United States Department of the Interior
Geological Survey
Washington, D. C. 20242

Reference: Source Material License SUB-1010, Docket 40-827,
Kerr-McGee Sequoyah Facility

Subject: Summary list of replacement pages, Revision 4/10/70

FIGURE IV-1
Revision 4/10/70

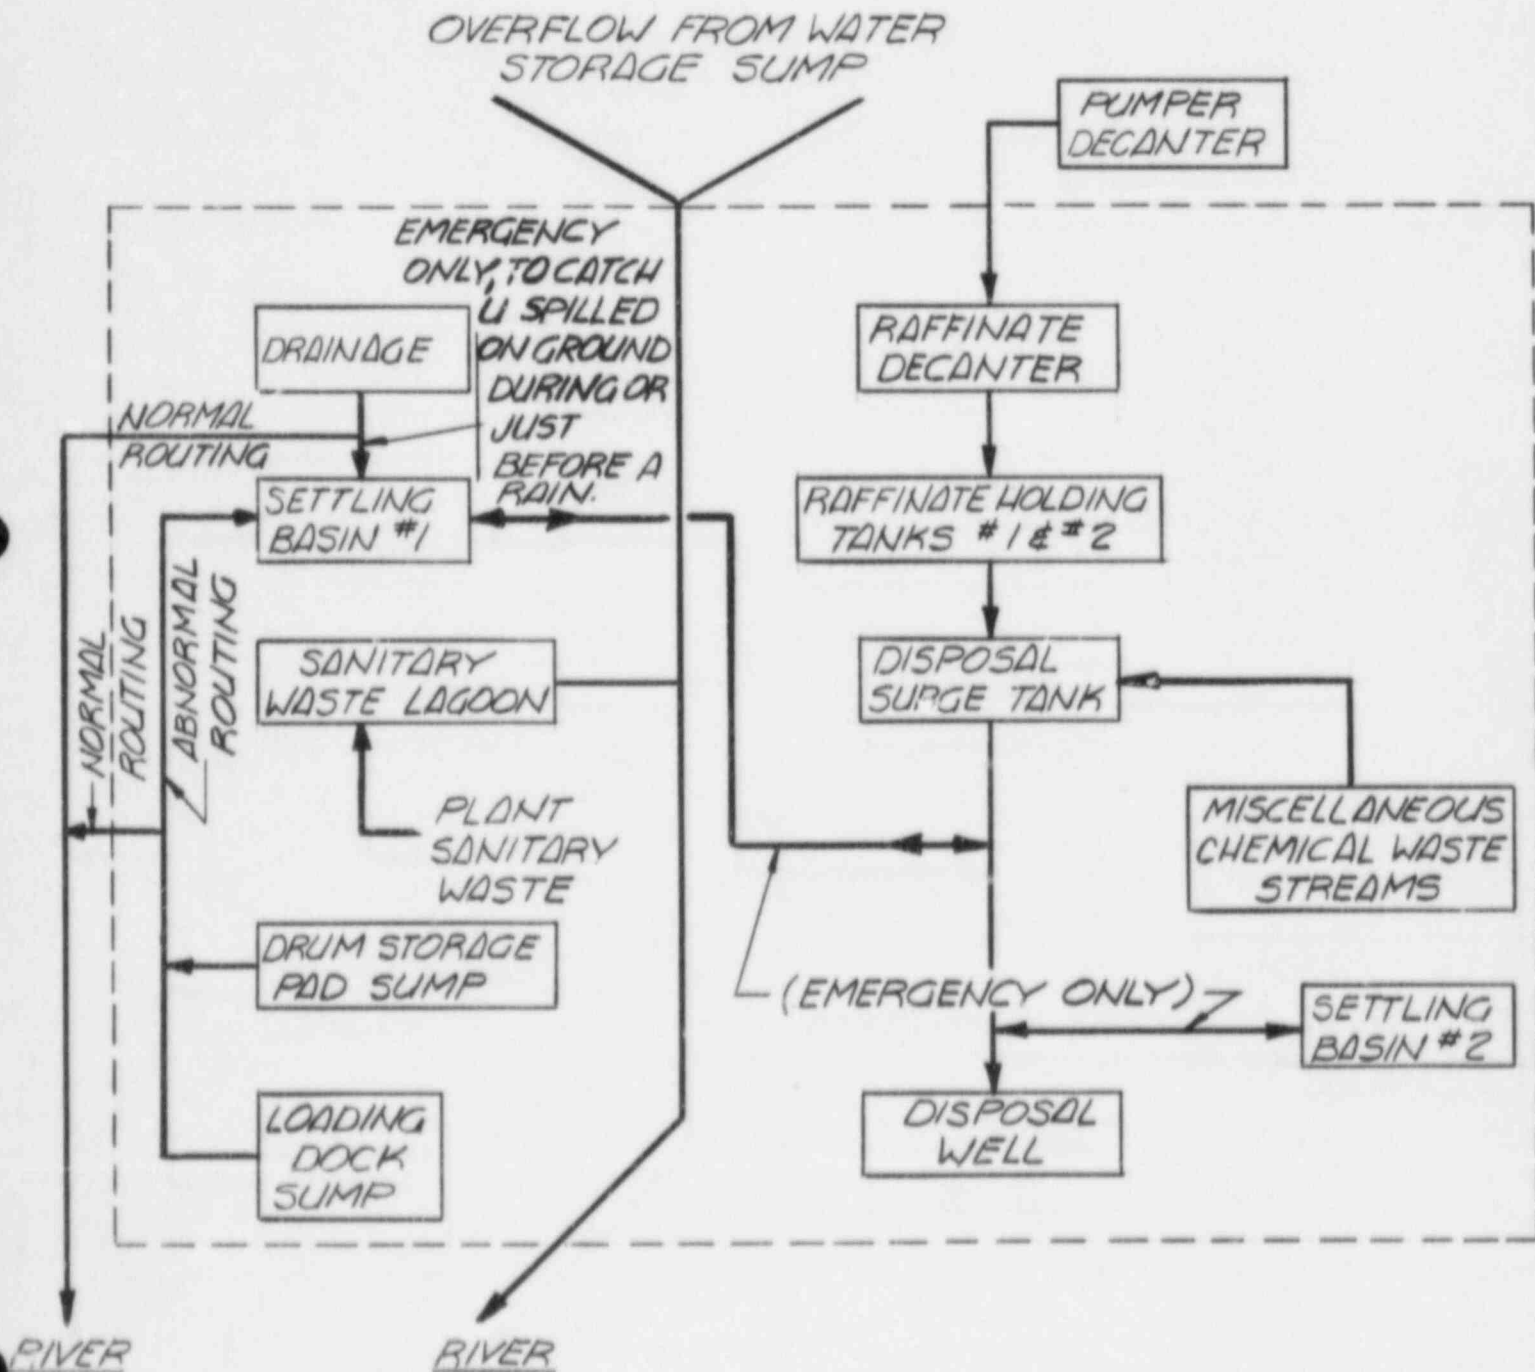
<u>New Pages</u> <u>(4/10/70)</u>	<u>Revision Reason</u>	<u>Replaces Pages</u> <u>(2/3/70)</u>
I-3	Added specific approval request to exceed 10CFR20 limits for well disposal.	I-3
Fig. III-2	Raffinate to well disposal	Fig. III-2
III-3	Raffinate to well disposal	III-3
IV-1 to IV-6.1 and Fig. IV-1 (7 pages)	Partial revision of Section IV - Waste Disposal to reflect waste well disposal	IV-1 to IV-6.1 (Figs. IV-1 and IV-2) (9 pages)
IV-7	Liquid waste releases	IV-7
<hr/> Total 11 new pages plus Appendix B		<hr/> Total 13 pages to be removed

A simplified sketch of the liquid waste system is shown on Figure IV-1. The Oklahoma Water Resources Board has approved the overall waste treatment plan within their jurisdiction.
